THE ILLINOIS STATE TOLL HIGHWAY AUTHORITY

DESIGN BULLETIN No. 20-03

SUBJECT: Noise Abatement Wall Updates

The following revisions and additions to the Illinois Tollway Standard Drawings Sections G and F19, Base Sheets M-BRG-529, M-BRG-531, M-BRG-532 and Structure Design Manual Figure 15.5.1.6 and Article 22.6.

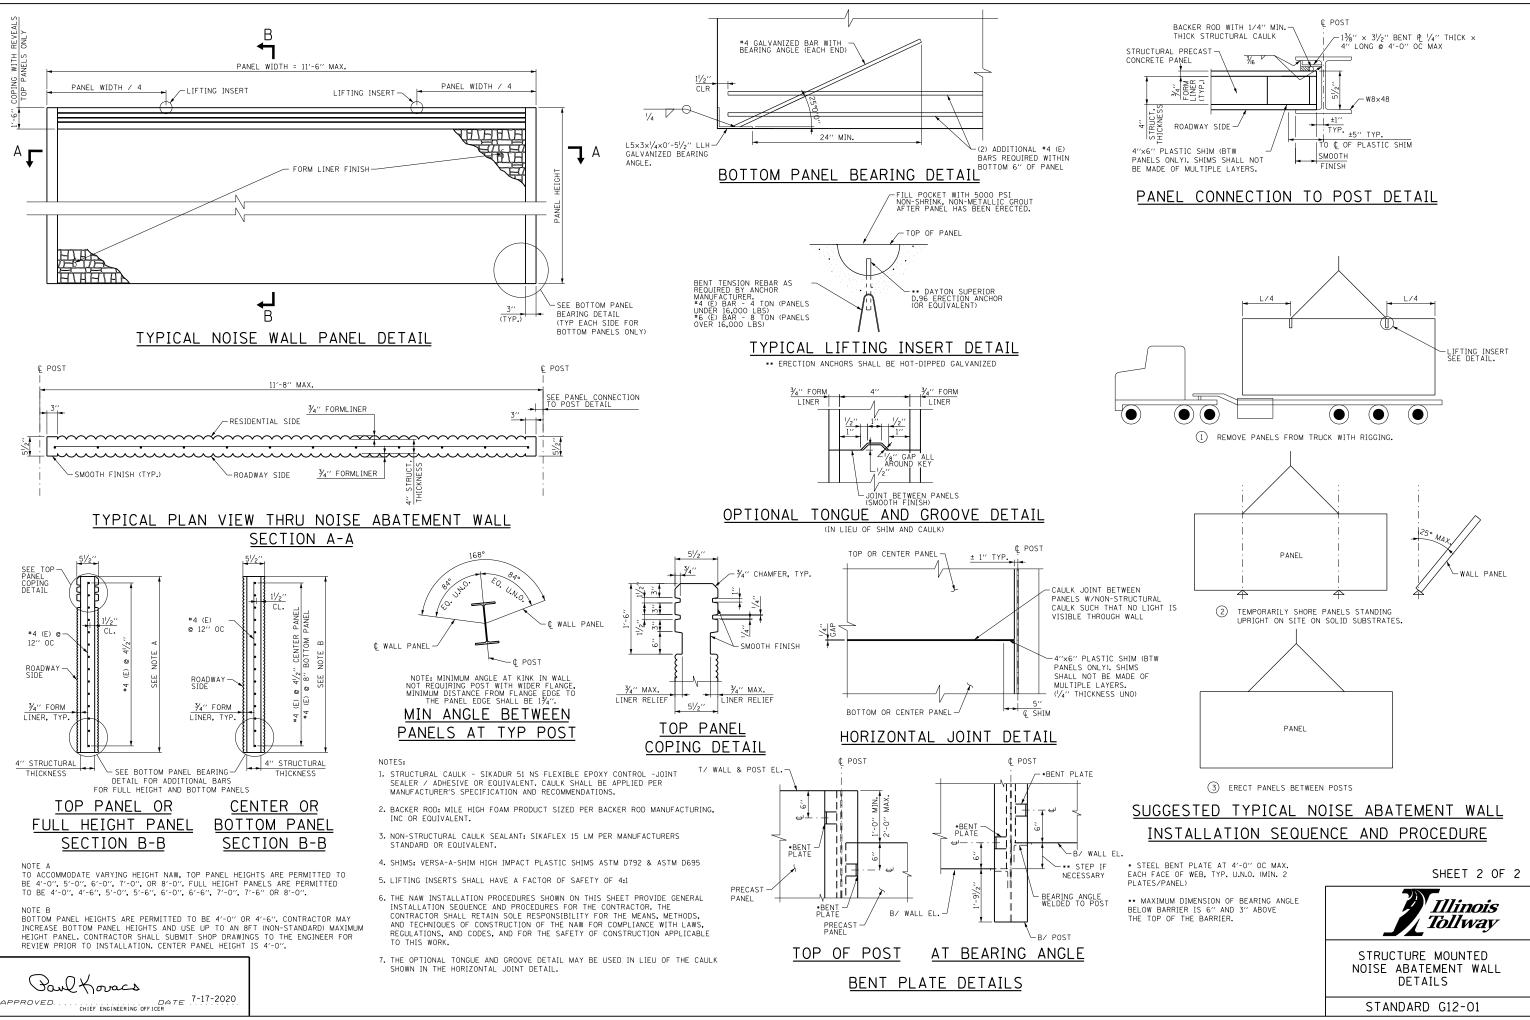
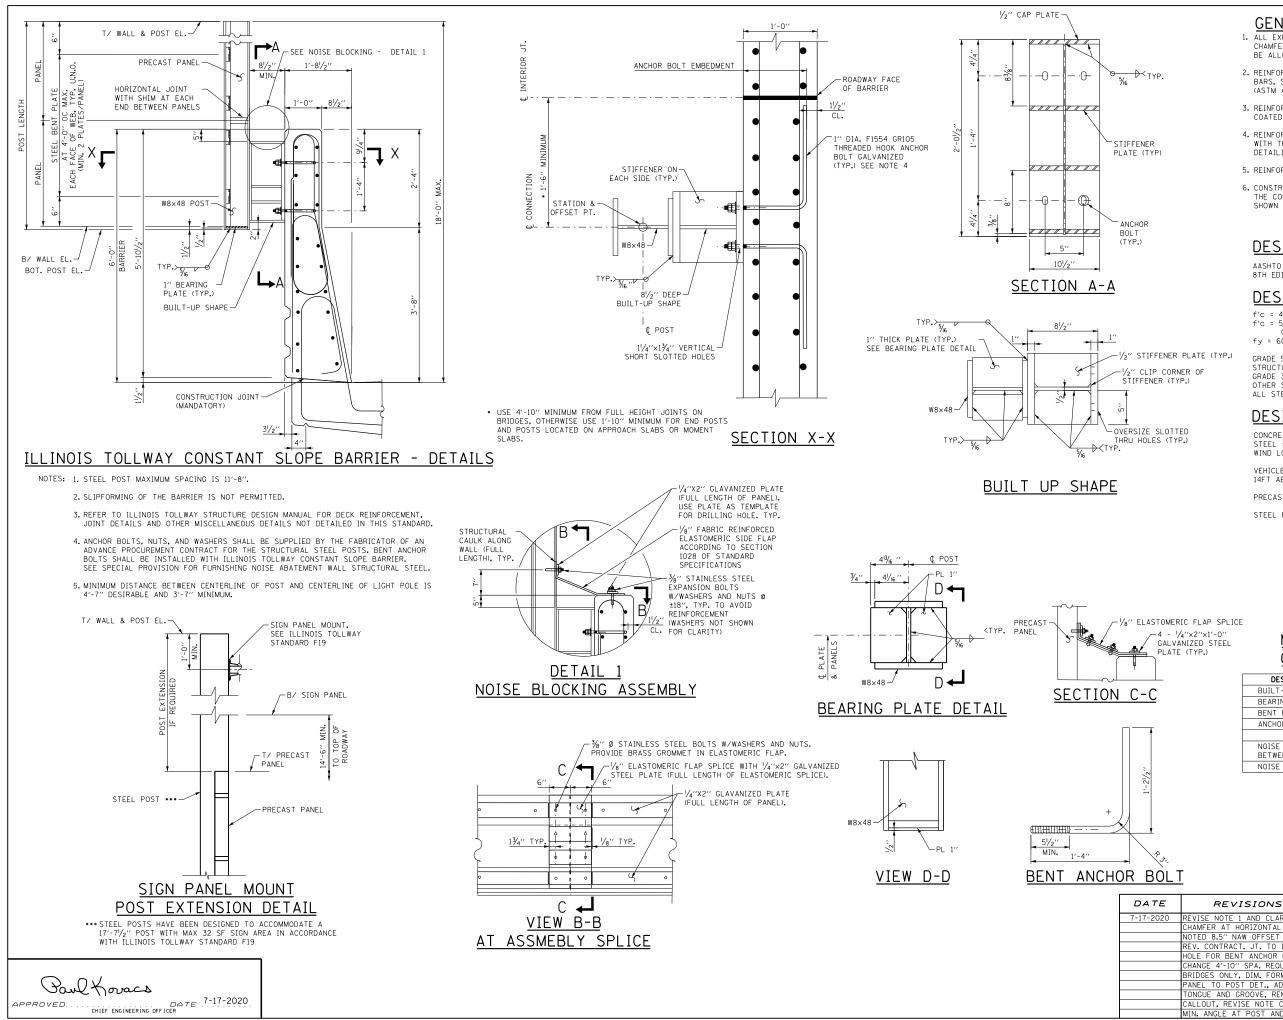
All Standard Drawings in Section G have been updated to clarify no chamfer at the horizontal joint between panels. A tongue and groove detail has been added as an option in lieu of the caulk joint with shim as shown in the Horizontal Joint Detail. Notes have also been added which allow the Contractor to increase panel heights for certain panels, up to a maximum height. Minimum angle between panels and posts has been increased to 84 degrees for all Standard Drawings. Clarification has been added to Standard Drawing G12 clarifying the maximum limits of the bottom of panel above and below the barrier and Standard Drawings G12 and G13 have updated callouts for contraction joints to interior joints to be consistent with the Illinois Tollway Structure Design Manual and changed the 4'-10" spacing requirements of posts to full height joints to apply only to bridges and 1'-10" post to full height joints on approach slabs and moment slabs. Offsets between to back of the barrier and face of the noise abatement wall have been noted as minimum dimensions as well. Details for filter fabric at the unbalanced soil conditions, shims shown as 6" minimum, clarification to the bearing of angle shown in the 90 Degree Turn Detail and removing the redundant panel width shown in Section B-B have also been included in Standard Drawings G15 and G16. Standard Drawing G15 also shows the balanced soil condition can accommodate up to 9" of unbalanced soil load and additional updates have been made in G16 including the post callout as shown in the Sign Panel Mount Post Extension Detail and revising the spacing of end bars shown in Section A-A to 14".

DATE		SHEET 1 OF 2
DATE	REVISIONS	
7-17-2020	REVISE NOTE 1 AND CLARIFIED NO	
	CHAMFER AT HORIZONTAL JOINTS,	llinois
	NOTE 10" NAW OFFSET AS MIN.,	
	ADD MAX. SEAT LIMITS ABOVE AND	Tollway
	BELOW BARRIER IN TYP. SECTION,	
	REV. CONTRACT. JT. TO INTERIOR JT.,	
	HOLE FOR BENT ANCHOR REV. TO 11/4"	STRUCTURE MOUNTED
	CHANGE 4'-10" SPA. REQUIRE FOR	
	BRIDGES ONLY, DIM. FORM LINER ON	NOISE ABATEMENT WALL
	PANEL TO POST DET., ADD DET. FOR	DETAILS
	TONGUE AND GROOVE, REMOVE REVEAL	
	CALLOUT AND REVISE NOTE B, INC.	STANDARD G12-01
	MIN. ANGLE AT POST AND PANELS,	STANDARD GIZ-UI

1. ALL EXPOSED CONCRETE EDGES SHALL HAVE A 3/4" X 45° CHAMFER, EXCEPT WHERE SHOWN OTHERWISE. NO CHAMFER WILL BE ALLOWED AT HORIZONTAL JOINTS BETWEEN PANELS.

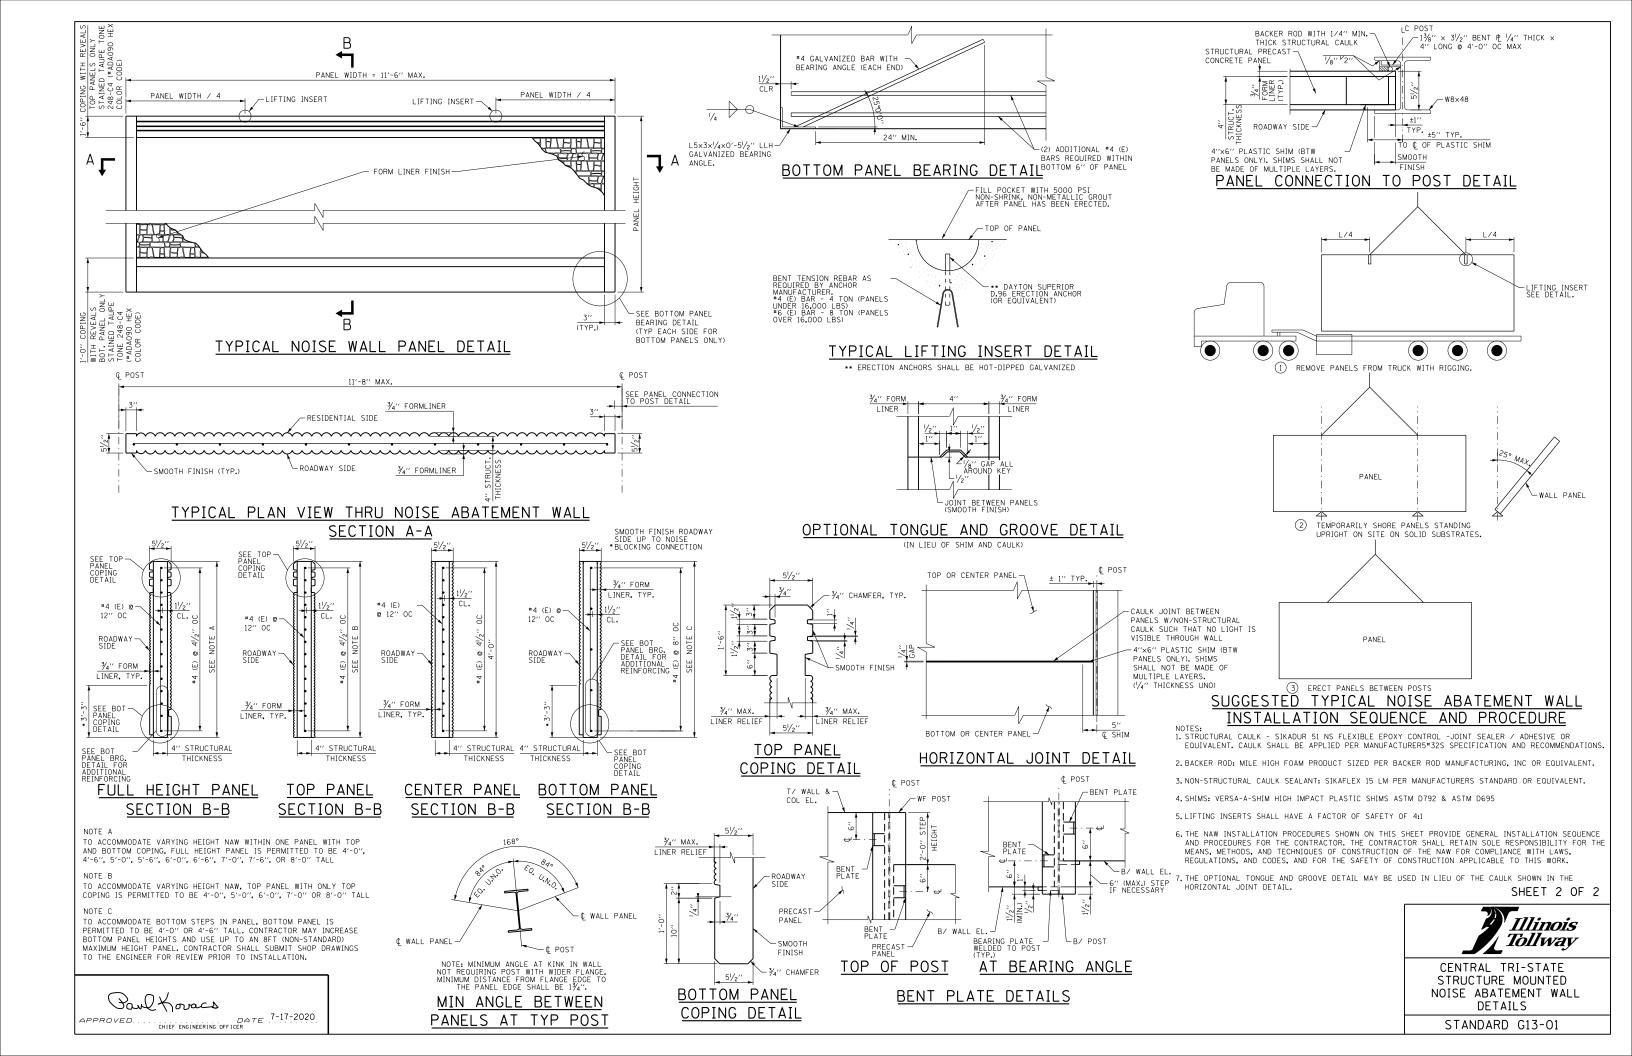
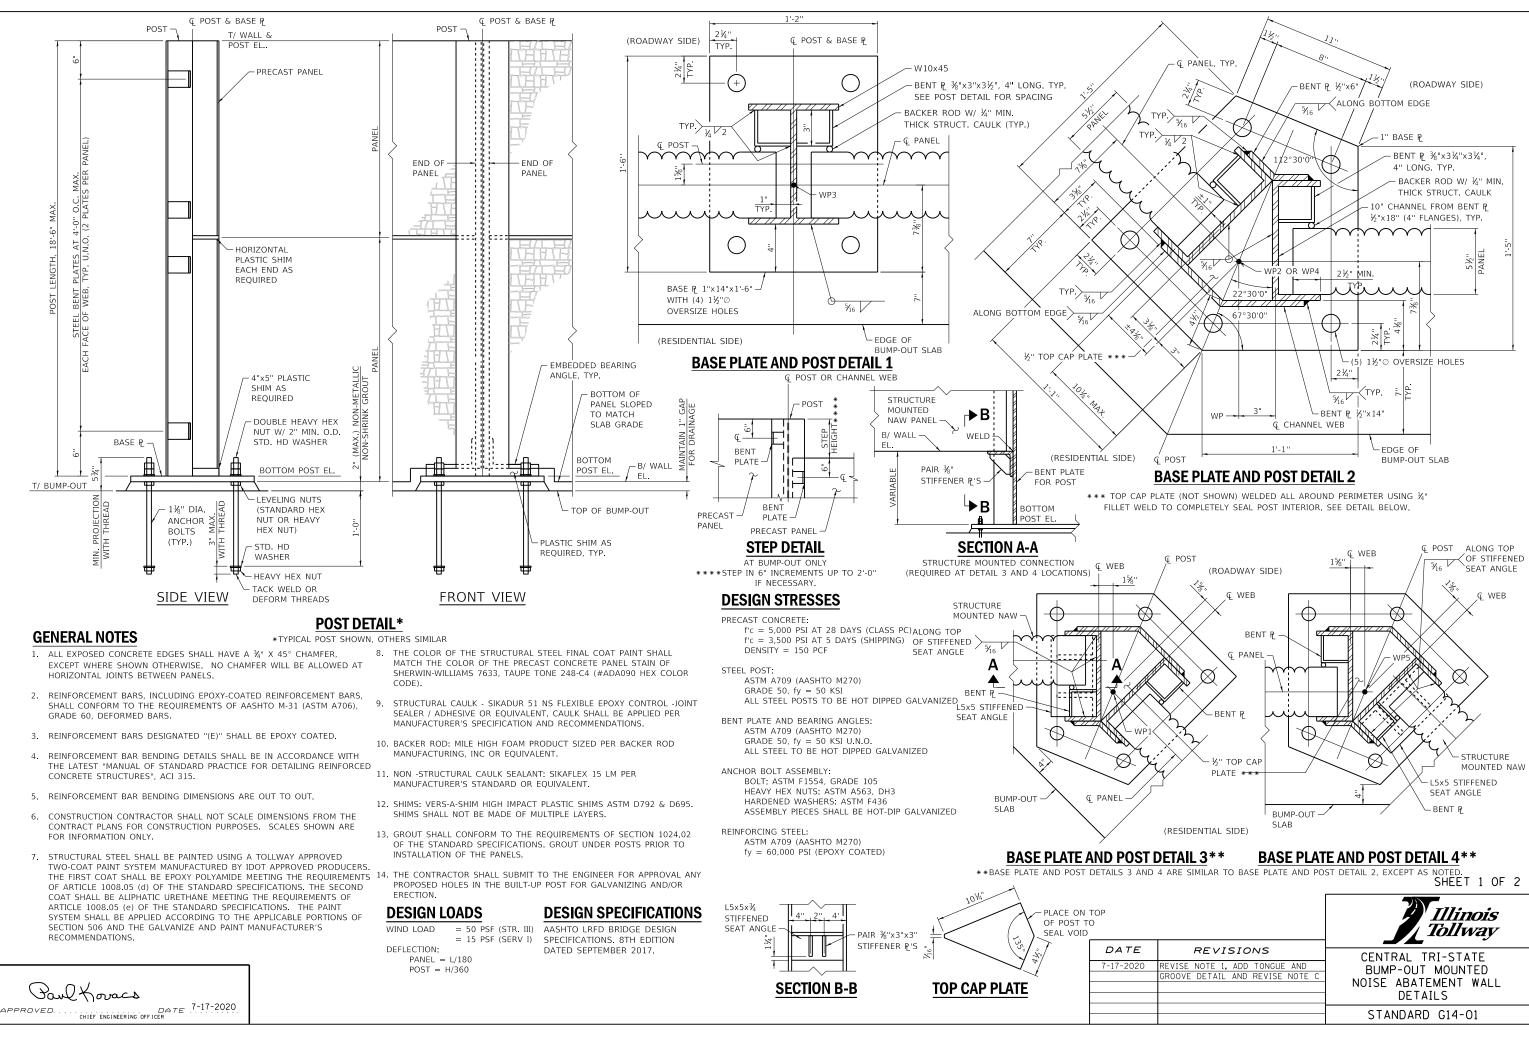
DAIL	NEVISIONS	lilinois 🖌
7-17-2020	REVISE NOTE 1 AND CLARIFIED NO	
	CHAMFER AT HORIZONTAL JOINTS,	Tollway
	NOTED 8.5" NAW OFFSET AS MIN.,	
	REV. CONTRACT. JT. TO INTERIOR JT.,	
	HOLE FOR BENT ANCHOR REV. TO $1^{1}/_{4}$ ",	
	CHANGE 4'-10" SPA. REQUIRE FOR	STRUCTURE MOUNTED
	BRIDGES ONLY, DIM. FORM LINE ON	NOISE ABATEMENT WALL
	PANEL TO POST DET., ADD DET. FOR	
	TONGUE AND GROOVE, REMOVE REVEAL	DETAILS
	CALLOUT, REVISE NOTE C, INC.	STANDARD G13-01
	MIN. ANGLE AT POST AND PANELS,	STANDAND GIS-OI

- 1. ALL EXPOSED CONCRETE EDGES SHALL HAVE A $\frac{3}{4}$ '' X 45° CHAMFER, EXCEPT WHERE SHOWN OTHERWISE. NO CHAMFER WILL BE ALLOWED AT HORIZONTAL JOINTS BETWEEN PANELS.
- 2. REINFORCEMENT BARS, INCLUDING EPOXY-COATED REINFORCEMENT BARS, SHALL CONFORM TO THE REQUIREMENTS OF AASHTO M-31 (ASTM A706), GRADE 60, DEFORMED BARS.
- 3. REINFORCEMENT BARS DESIGNATED "(E)" SHALL BE EPOXY COATED.
- 4. REINFORCEMENT BAR BENDING DETAILS SHALL BE IN ACCORDANCE WITH THE LATEST "MANUAL OF STANDARD PRACTICE FOR DETAILING REINFORCED CONCRETE STRUCTURES", ACI 315.
- 5. REINFORCEMENT BAR BENDING DIMENSIONS ARE OUT TO OUT.
- 6. CONSTRUCTION CONTRACTOR SHALL NOT SCALE DIMENSIONS FROM THE CONTRACT PLANS FOR CONSTRUCTION PURPOSES. SCALES SHOWN ARE FOR INFORMATION ONLY.

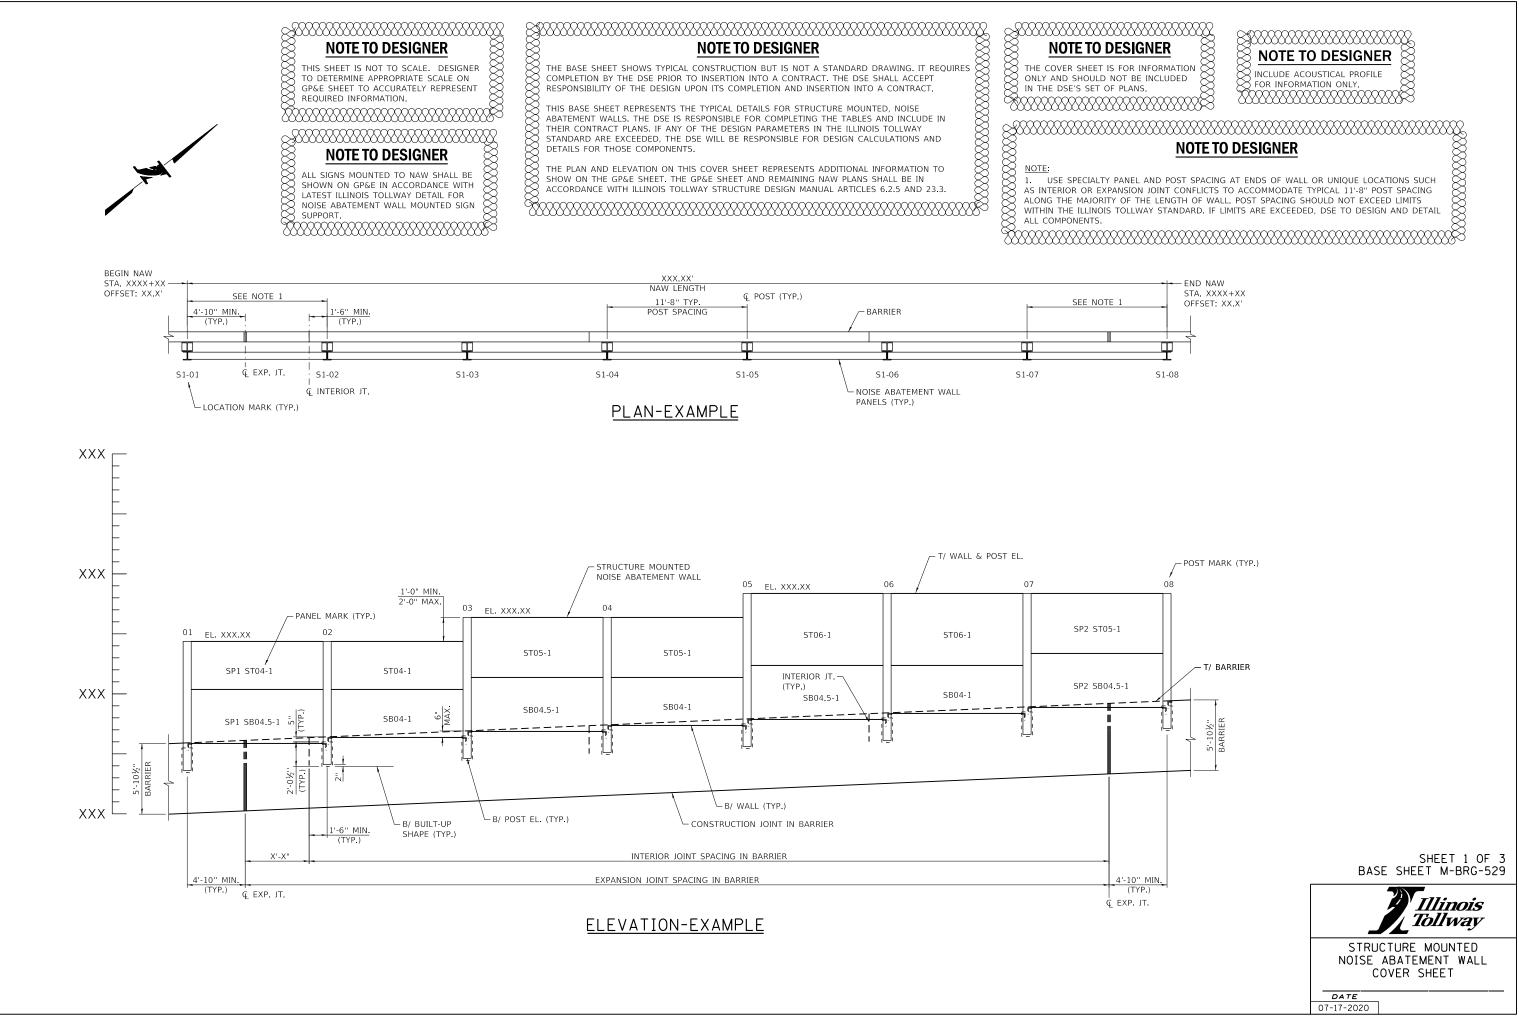
Sheet 2	Add note to designer referring to M-BRG-531 for bump-outs									
	Changed Illinois Tollway references and Construction Specifications from 2019 to 2020									
	Add note allowing Contractor to increase bottom panel heights									
	Add G12 to note referencing Illinois Tollway Standards									
	Add note to designer referencing M-BRG-530 base sheet for expansion joints and to identify which panel require special details

* CONTRACTOR MAY INCREASE BOTTOM PANEL HEIGHTS AND USE UP TO AN 8FT (NON-STANDARD) MAXIMUM HEIGHT PANEL. THE ADJACENT TOP PANEL MAY ALSO BE ADJUSTED, PROVIDED STANDARD PANEL HEIGHTS AS SHOWN IN STANDARD G12 ARE USED. CONTRACTOR SHALL SUBMIT SHOP DRAWINGS TO THE ENGINEER FOR REVIEW PRIOR TO INSTALLATION

SHEET 4 OF 4 BASE SHEET M-BRG-532

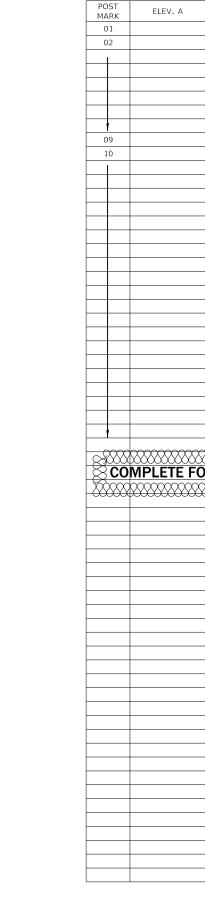
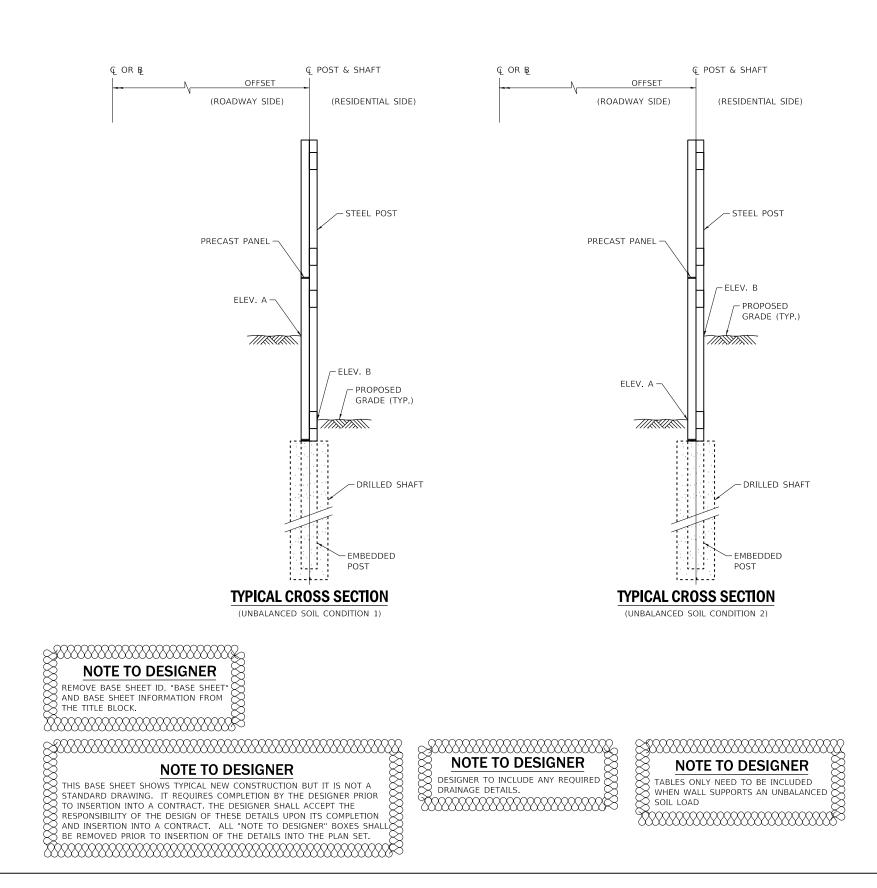
Sheet 3	Add NAW Type designation									
Sheet 4	New Base sheet to be used to show final grade for unbalanced soil conditions									
<u> </u>

FIGURE 15.5.1.6

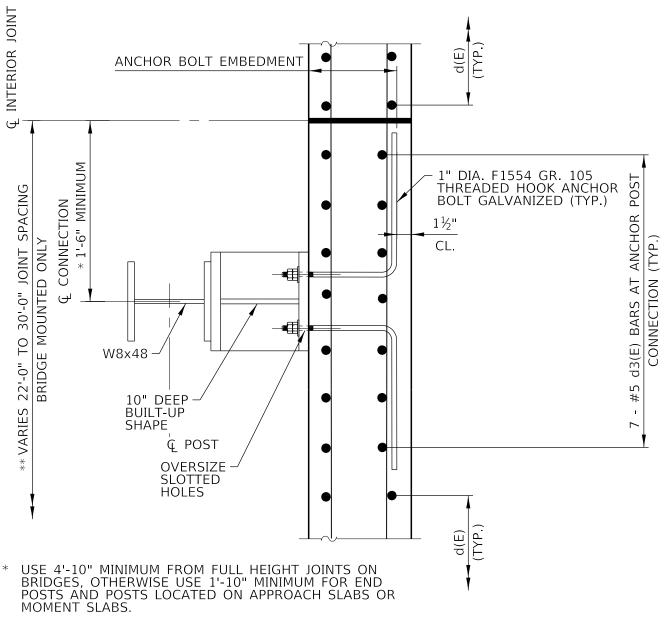
Figure 15.5.1.6 has been revised to allow the noise abatement wall post to full height joint spacing to be reduced to 1'-10" on approach slabs and moments slabs but remain 4"-10" on bridges. Callout for Contract Joint has been revised to Interior Joint and note referring to contraction joints on moment slabs has been removed. Article 22.6 of the Illinois Tollway Structure Design Manual has been revised to indicate sawed controlled joints are only allowed on 44" parapets when slip-formed. Details for 72" barrier shall follow Figure 15.5.1.8 and Figure 15.5.1.4 for the 44" parapet.
